## Letter of Commentary - Inspection Review

### **J6102 - Site Inspection - 116 Gore Street, Bluff**

Consideration of how or if it is practical to strengthen the two buildings 1&2 as discussed by the Heritage Properties NZ in their email of the 19<sup>th</sup> feb 2018.

*F14; Note the concrete fix ups with the diagonal shear cracks radiating up from the vertical edges about the concrete. This whole wall has been undermined with its lower removal of the historic internal load bearing wall as can be seen off the original drawings in Fig 17.*

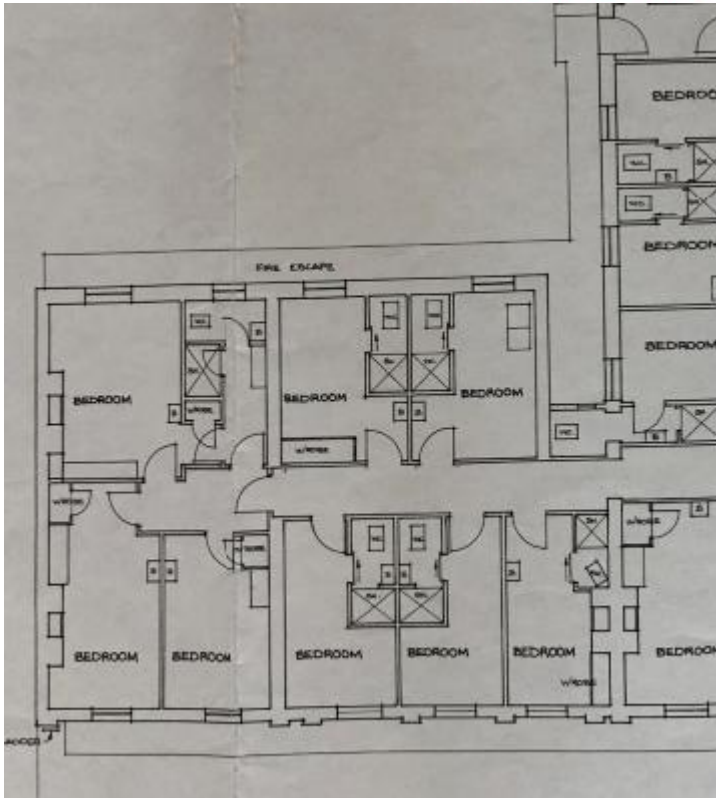
*F12; This chimney breast shows how the bricks are not interlocked into the opening and flue which is poorly detailed as there is no strength between these changes, the bricks are poorly cemented together and their quality is not far off rubble as can be seen in a few of them.*

*F13; Rubble of bricks are shown with poor cemented interlacing to the front bricks, such situations in this building is common.*
